164-192 WILLIAM STREET

SSDA (SSD-80211463) RTS Comments

TTW's responses to the agency comments on the Flood Impact and Risk Assessment (FIRA) Report for 164-192 William Street (SSD-80211463) are provided below.

Figure 1: Flood ingress points in relation to flood depths and levels in the 1% AEP CC2030 event

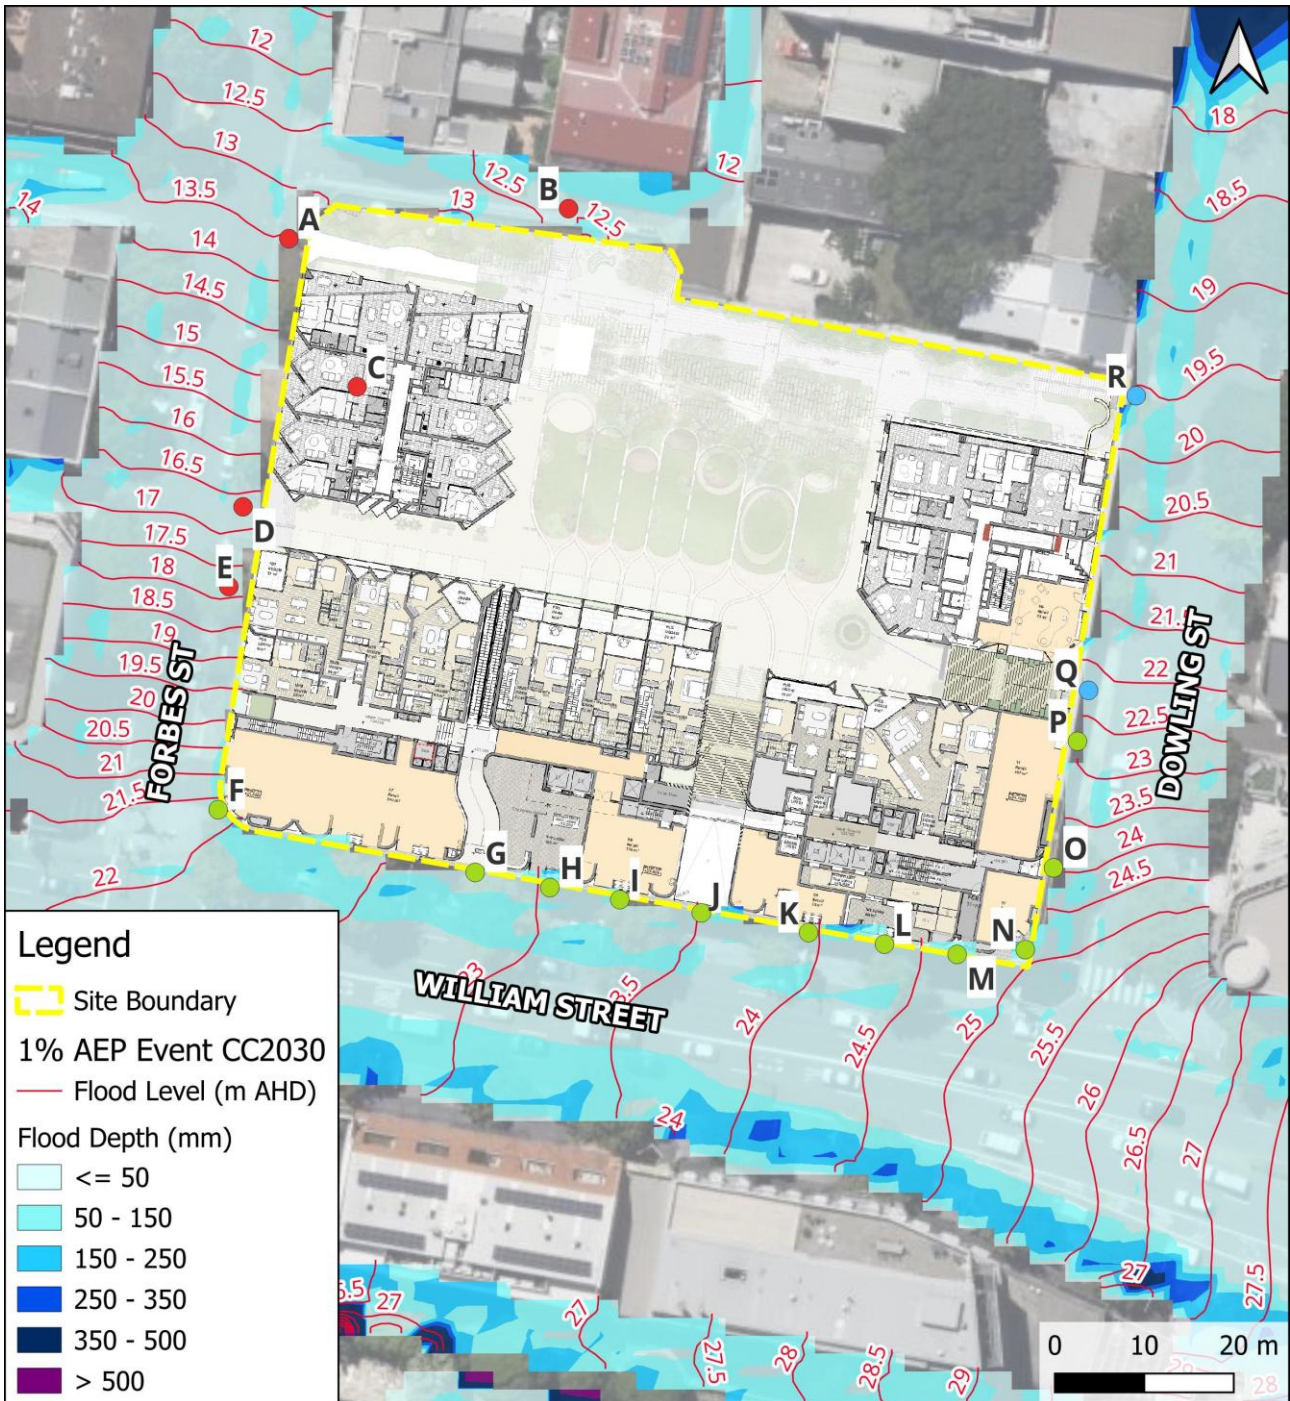
The finished floor levels for the retail tenancies on William Street and Bridge Street must also comply with 1% AEP CC2030 levels.	<p>As shown in the flood depth and level mapping for the 1% AEP CC2030 scenario (attached in Appendix A, Figure 1 of this letter) and summarised in Table 10 of TTW's FIRA, flood depths at all retail tenancy ingress points are less than 150mm in this event.</p> <p>Consistent with the adopted assessment approach and Council's definition of flooding, these entry points are not considered flood affected under the 1% AEP CC2030 scenario. Accordingly, the proposed finished floor levels for the retail tenancies are considered compliant from a flood risk perspective.</p>
NSW SES – 12 November 2025		
S.1	We recommend the consent authority ensures that all openings to the basement	As aforementioned (Item 13), basement openings have been assessed in accordance with Council's
